CPED STAFF REPORT

CPC Agenda Item #8
 July 14, 2014
 BZZ-6617

Property Location: 101 3rd Avenue South
Project Name: Mill City Quarter Woonerf
Prepared By: [Janelle Widmeier](#), Senior City Planner, (612) 673-3156
Applicant: Mill Place Inc.
Project Contact: Gretchen Camp, BKV Group Inc.
Request: To allow modifications to an accessory parking lot.
Required Applications:

Conditional Use Permit	Amendment for an accessory parking lot located in the DP Downtown Parking Overlay District.
Variance	Of the DP Downtown Parking Overlay District standards to allow more than 20 parking spaces.
Site Plan Review	For an accessory parking lot.

1 LANDSCAPE PLAN
1/20"=1'-0"

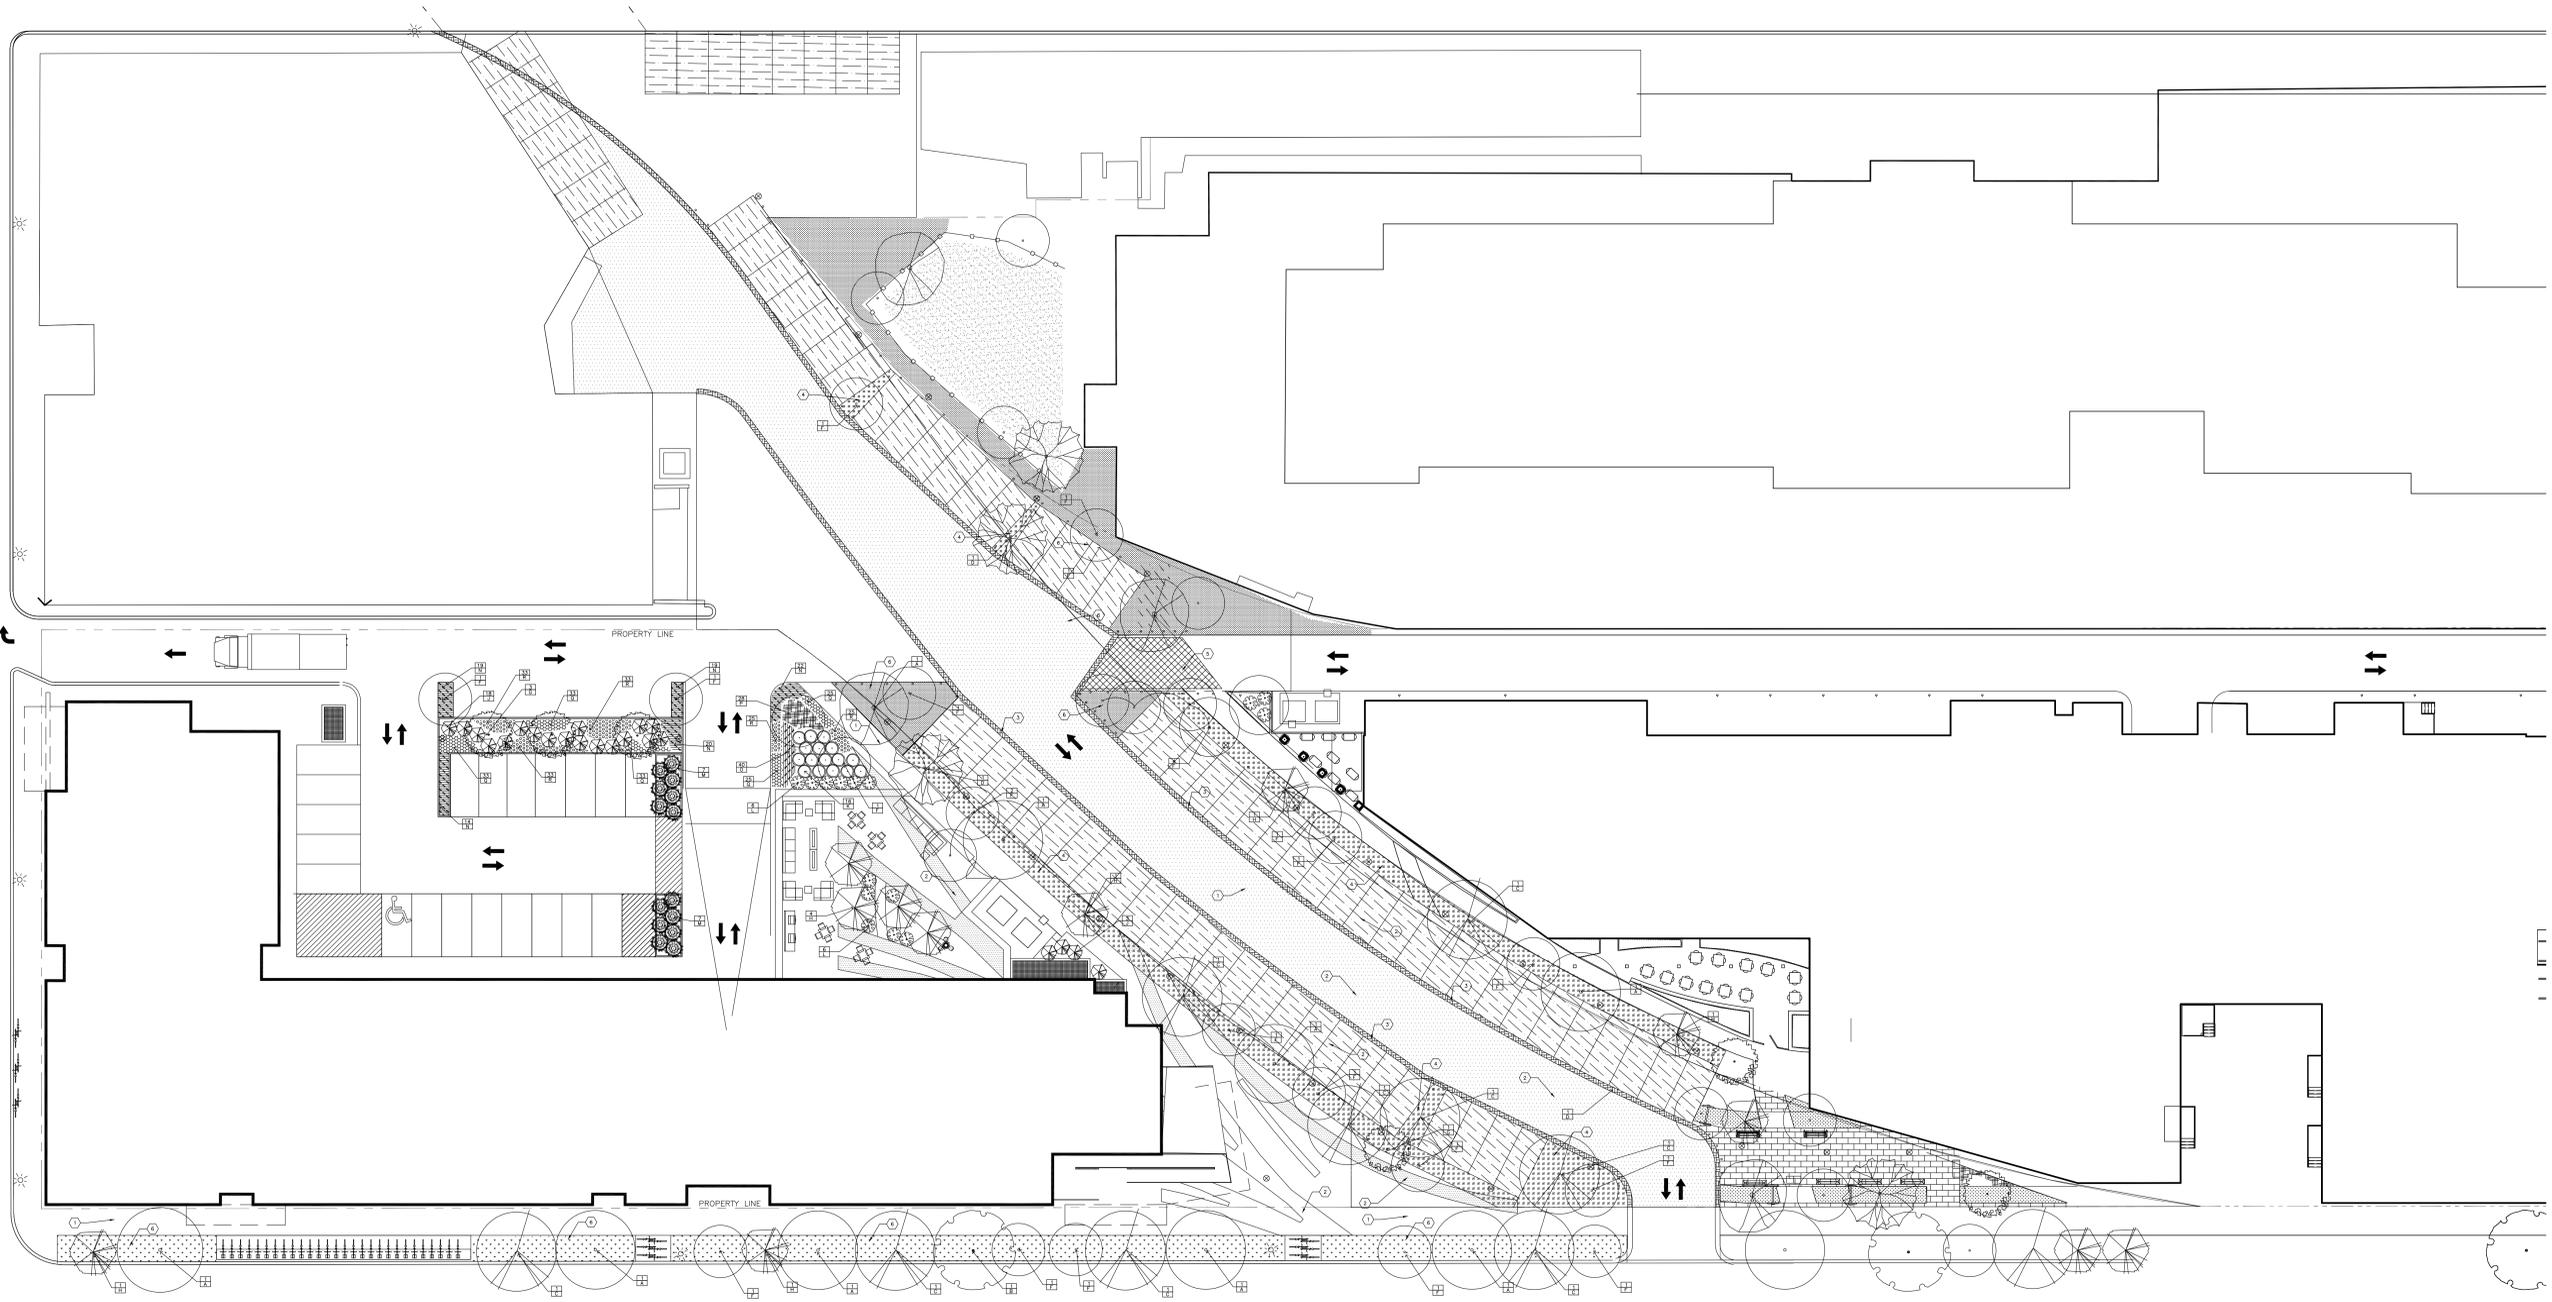
- The general landscaping requirements are included in the table below. As proposed, 1.1 percent of the net lot area will be landscaped. The minimum required number of canopy trees and shrubs also would not be provided on-site.

- A landscaped yard at least 7 feet in width with screening that is 3 feet in height and at least 60 percent opaque along with a minimum of 4 canopy trees is required along 2nd Street. A landscaped yard with the required screening is not proposed.

- A landscaped yard at least 7 feet in width with screening that is at least 6 feet in height and 95 percent opaque is required along the east property line between the parking area and the adjacent residential property. Landscaped yards and screening is not proposed along the east property line or adjacent to the proposed developments.

- Some landscaping will be provided at the corners of the parking area unavailable for parking.
- Most of the parking spaces would not be located within 50 feet of an on-site tree. Some tree islands would not be at least 7 feet in width.

- Areas not occupied by buildings, parking or loading would be covered by turf or pervious pavers.
- Information is not provided on the landscape plan regarding the installation and maintenance of all landscape materials. Installation and maintenance will need to comply with section 530.210 of the zoning code.

- **Landscaping and Screening.** Alternative compliance is requested for each of the landscaping and screening requirements. The site currently has no landscaping. The applicant is proposing to add 470 square feet of landscaping along with 4 canopy trees and 10 ornamental trees on-site. The applicant is also proposing to increase the number of trees in the 2nd Street public boulevard. In addition to these landscaping improvements, 1,825 square feet of pervious pavers are proposed. Although not located on the site, trees will be planted along both sides of the woonerf. Overall, a tree canopy will be created that covers most of the parking area. However, the no trees are proposed in the north end of the parking area and several of the on-site tree islands are less than 7 feet in width. Increasing the width of the tree islands and adding more trees may be possible without significantly altering the proposed plan. The placement of landscaped areas and plantings are intended to be less formal and reflect a volunteer growth pattern which is appropriate for this location in the historic district. A heavily landscaped site would also be less appropriate for a site that was once a railroad corridor, but the increase in pervious surfaces will significantly increase stormwater infiltration. The area of the site not occupied by the buildings is narrow. Providing the landscaped yards would likely eliminate most of the parking. Providing screening would interfere with the open feeling intended for the woonerf. There are also no windows on the ground floor of the adjacent residential high-rise because it is occupied by enclosed parking. Between the high-rise and the parking is a pet exercise area. A 6-foot tall fence would be ineffective screening for the residences overlooking the site and could create safety issues for the pet exercise area with the lack of ground level visibility from surrounding areas. For these reasons, staff is recommending that the planning commission grant alternative compliance and approve the plan as proposed, with the exception of requiring the applicant to explore opportunities to locate all parking spaces within 50 feet of a tree and provide a minimum width of 7 feet for tree islands.

1. The applicant shall explore opportunities to locate all parking spaces within 50 feet of a tree and provide a minimum width of 7 feet for tree islands as required by section 530.170 of the zoning code.

5. Department of Community Planning and Economic Development staff review and approval of the final site, lighting and landscape plans.
6. Site improvements required by Chapter 530 or by the City Planning Commission shall be completed by July 14, 2016, unless extended by the Zoning Administrator, or the permit may be revoked for non-compliance.

1 SITE PLAN
A010 1/16"=1'-0"

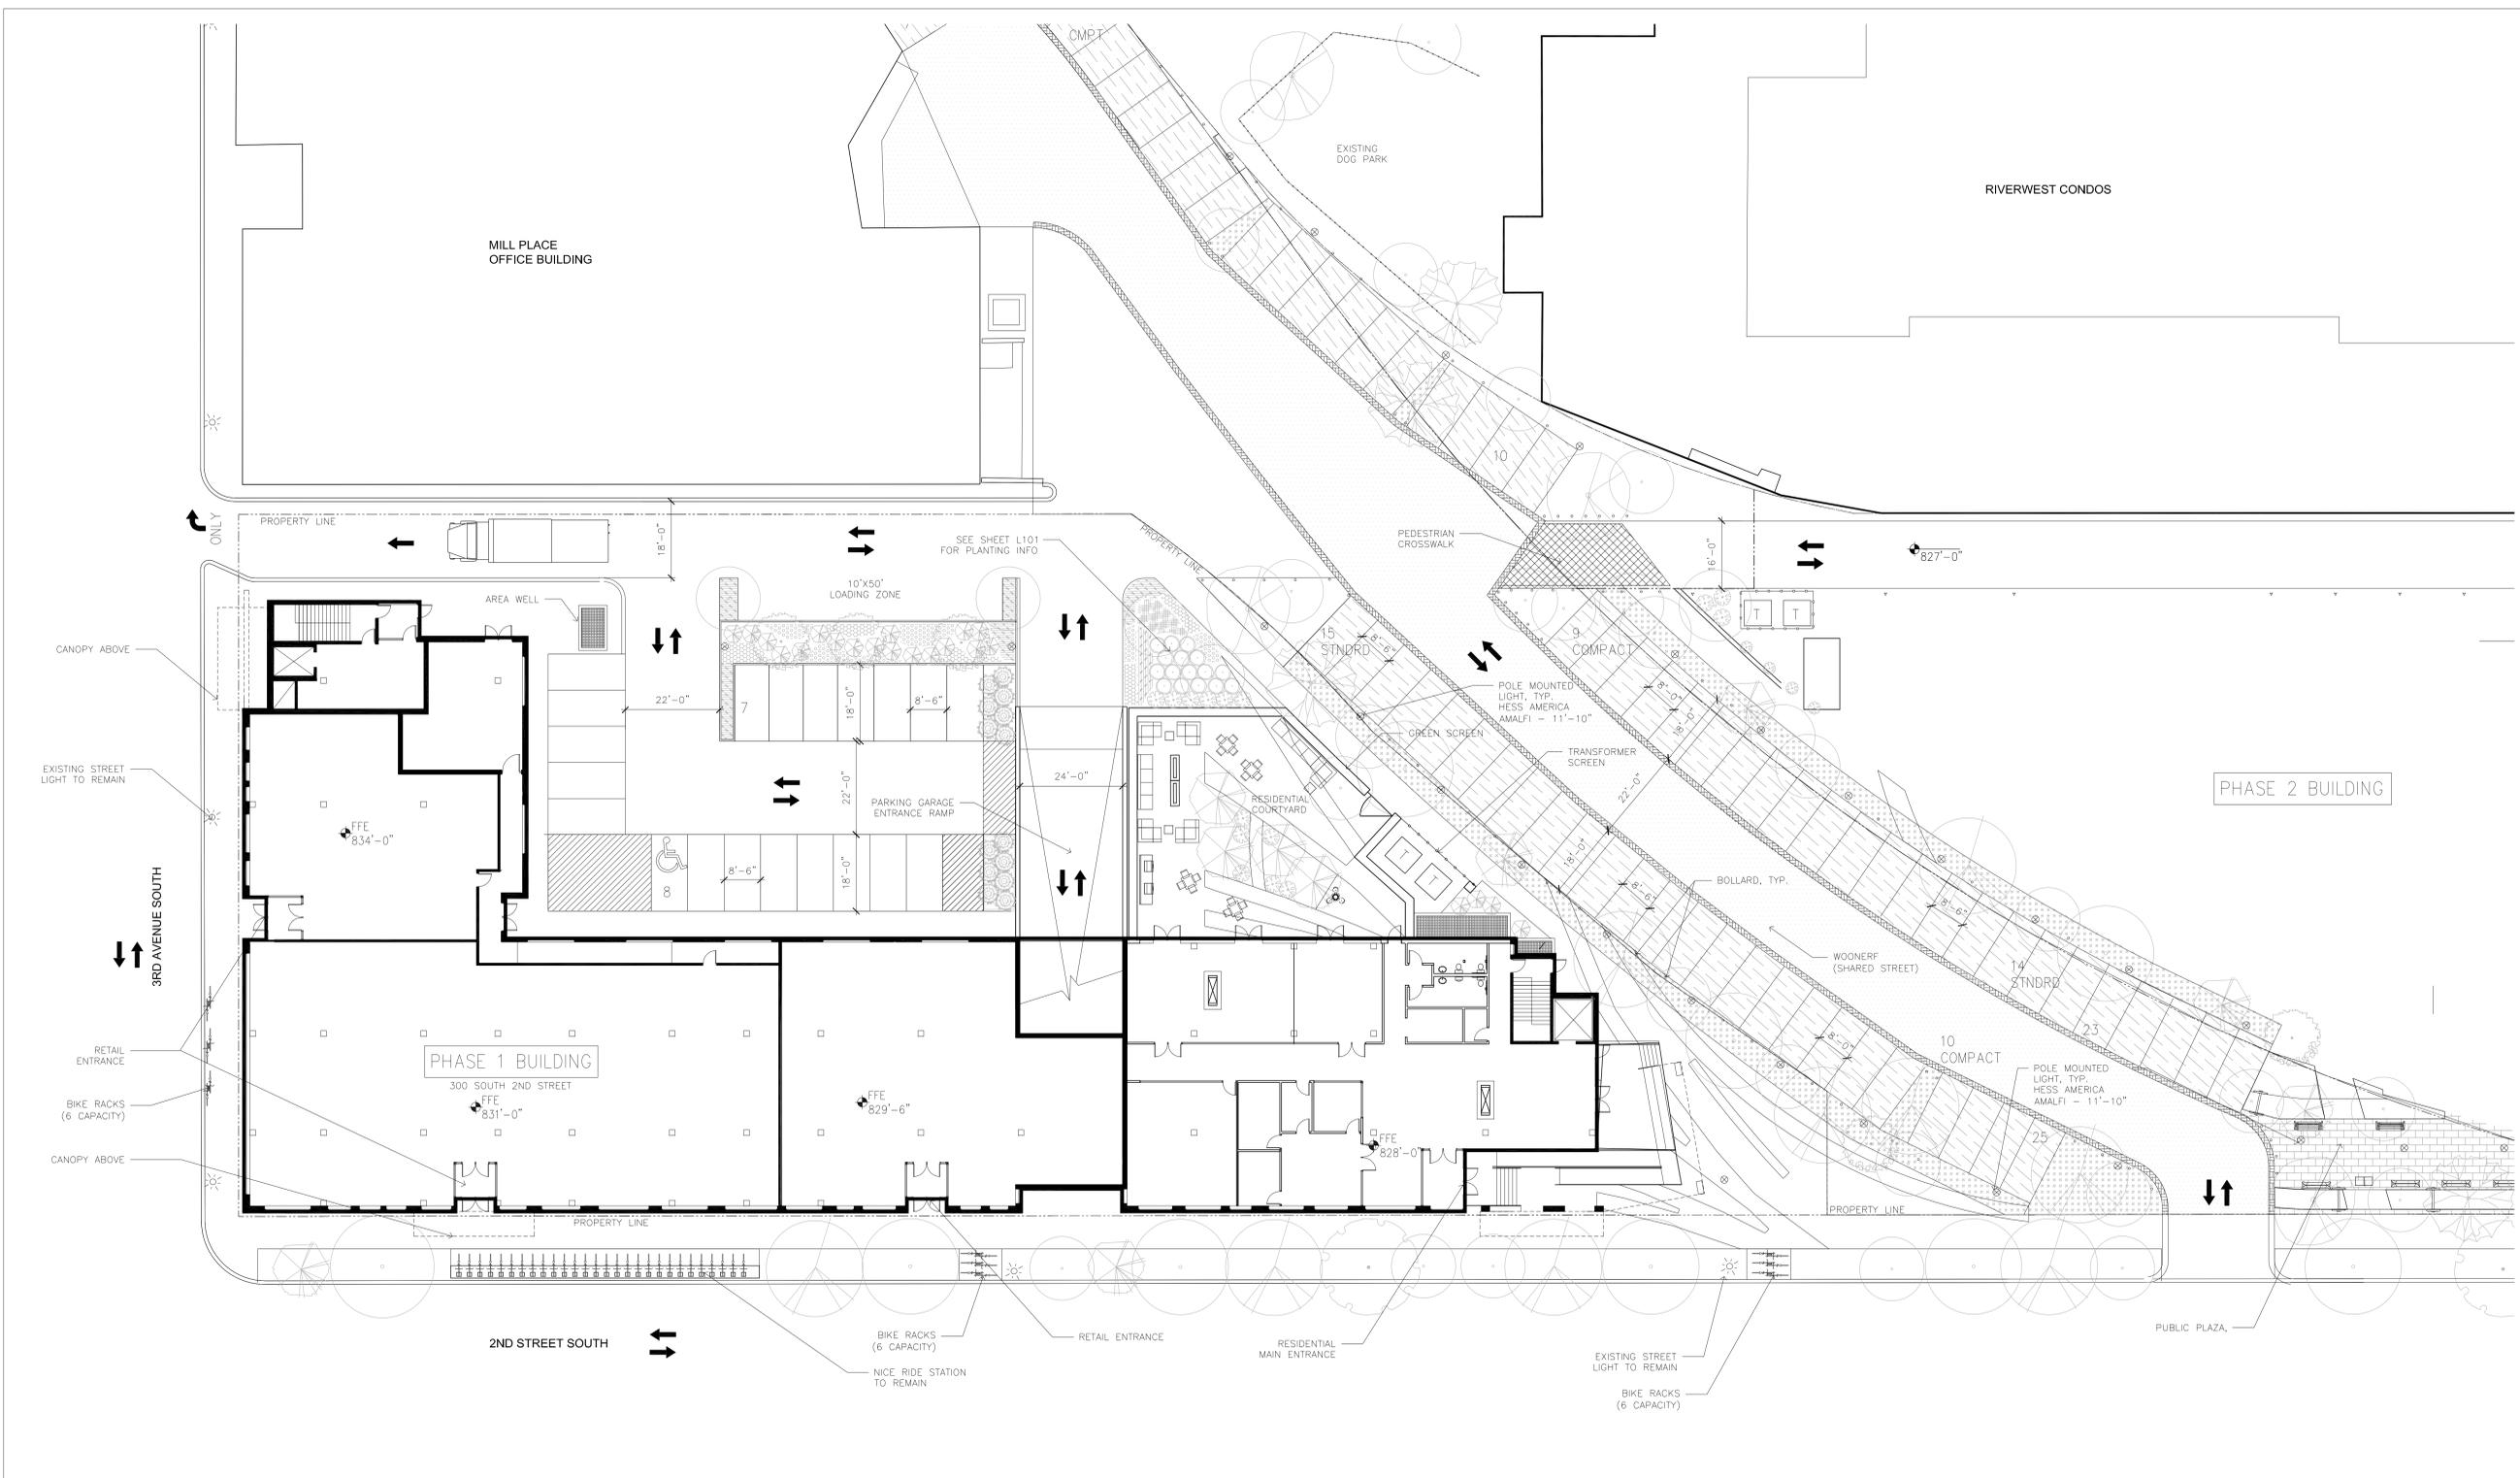
- Two loading areas exist on the site. They will not be affected by the proposed site changes.
- At least 4 accessible spaces are required. No accessible spaces are shown on the plan. They will need to be provided as required and shown on the final plans.

- The driveway curb-cut width will not exceed 25 feet.
- Maneuvering is designed to occur on-site, except for the spaces adjacent to the 1st Street bridge. This issue will need to be addressed on the final plans.

- The site plan (Sheet A010) identifies a canopy overhanging the Public right-of-way along 3rd Ave. S. and appears to indicate a bus shelter (a transit stop does not exist at this location). Metro Transit has been contacted and is not currently aware nor advocating a bus reroute that would accommodate this proposed location; any proposed transit stop at this location shall be fully reviewed and approved by both the Traffic Department and Metro-Transit. All Metro Transit Bus Stops shall be clearly identified on the site plans; and changes proposed bus stop changes shall be coordinated with Metro- Transit, please contact Maurice Roers at (612) 349-7684 for further information.

2 TRANSFORMER SCREENING - ELEVATION
A010 1/4"=1'-0"

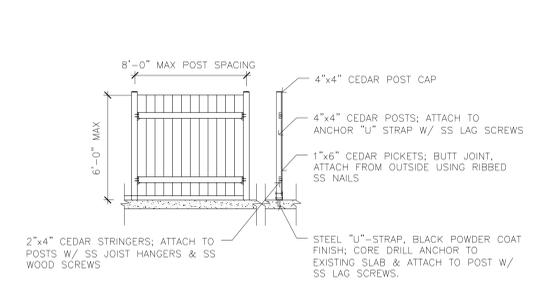
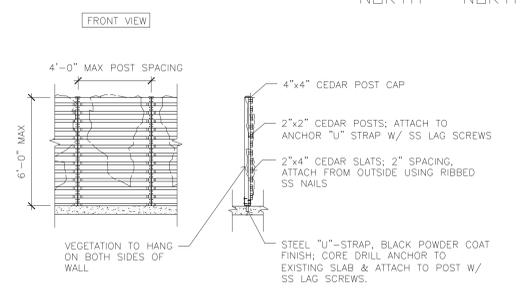
container or must be otherwise effectively screened from the street, adjacent residential uses located in a residence or office residence district and adjacent permitted or conditional residential uses. The storage location of the refuse containers is not indicated on the plan. Several pictures show a dumpster located outside of the building by one of the loading doors. Although the dumpster is partially screened by the building and an adjacent retaining wall, it is not screened from the east. It is expected that with a connection to the park on the other side of the 1st Street bridge, this screening won't be sufficient. However, some screening options may not be appropriate in a historic district. Therefore staff is recommending that the applicant work with CPED staff to explore a screening solution.

4. The applicant shall work with Department of Community Planning and Economic Development staff to provide appropriate screening for the refuse storage containers and the transformer.
